GATEWAY 36, BARNDSLEY
ROCKINGHAM - PHASE 2B

UNIT 7

MITIGATION MEASURES

Response to XQLA Landscape Review - rev. B

Fig. 2 Extract from *Phase 2 Proposed Earthworks 4652-2-JPG-SW-00-DR-C-1200-S2 Rev P11* showing original landform proposed

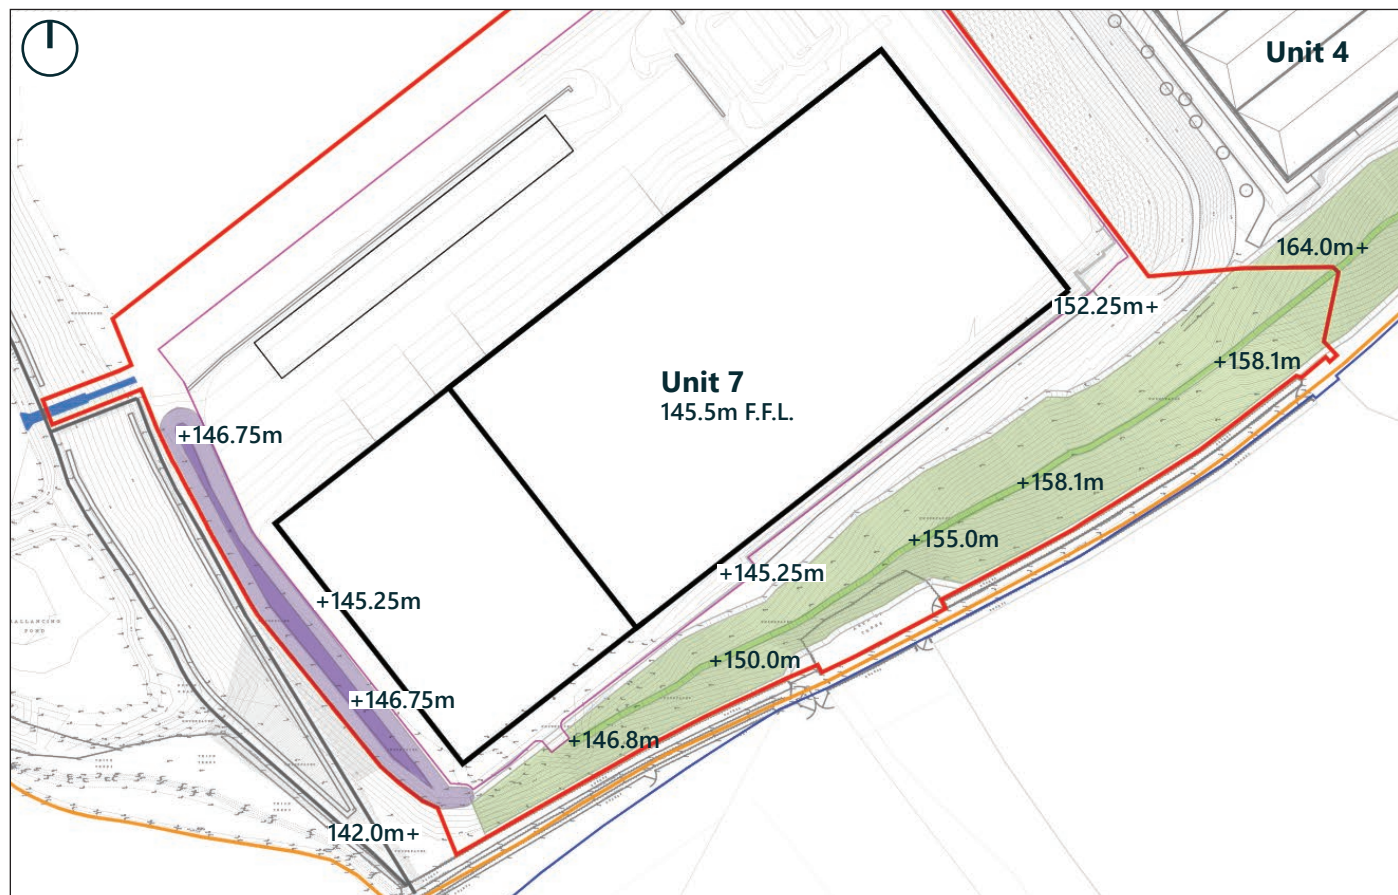
'Addendum E refers to an additional 6m landform to provide visual mitigation however, there is a 6m landform shown on the 2020 plans, (Ref: 12006-1-110 rev. J dated 01/07/20). Therefore, it is unclear if there is an existing mound or additional mitigation as a result of the proposal to increase the Unit 7 height. We assume this is an error and is the existing offer.'

- XQ refers to Masterplan-110 rev. J. This has been superseded by the submitted version i.e. Masterplan-110 rev. L.
- The approved levels plan from the original consent (August 2020) is '**Phase 2 Proposed Earthworks 4652-2-JPG-SW-00-DR-C-1200-S2 Rev P11**', therefore the comparison between plateau levels should be made against this proposal.

- **Original** - Essentially, the landform depicted in the above mentioned plan consisted of a bund situated between the building and an embankment. The bund was approximately 6m in height (152m-146m), while the embankment increased in height away from it (ranging from 147 to 155, depending on the position). - **See Fig. 2**

Fig. 5 Schematic sections through Proposed Landform West of Unit 7 (vegetation represented at maturity to illustrate screening proposed)

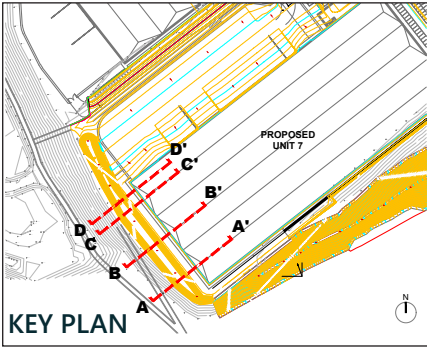
'Consider reducing the building height by reducing the FFL of Units 4-7, if possible, thereby increasing the level of the cover provided by the existing landscape, to the constructed units as well as, the proposed land forms and vegetation buffers.'

- Original – The landform slopes downward from the development plateau (car park level) at 144.0m to 138.0m (see Fig. 2).
- Proposed – The surplus material on site has been utilised to create a new landform to the west of Unit 7. This new bund is approximately 1.5m in height, with a ridge height of 146.75m (see Fig. 3).
- This has been illustrated using schematic sections in Fig. 5.
- The overall height increase of 5.1m for which the visual effects is being assessed reduces to 3.6m due to the proposal of the 1.5m-high landform, for views from the western receptors.

- This bund has also been planted with a 1x1m woodland matrix. It will offer enhanced screening for the identified receptors from the north-west and south-west of the site.
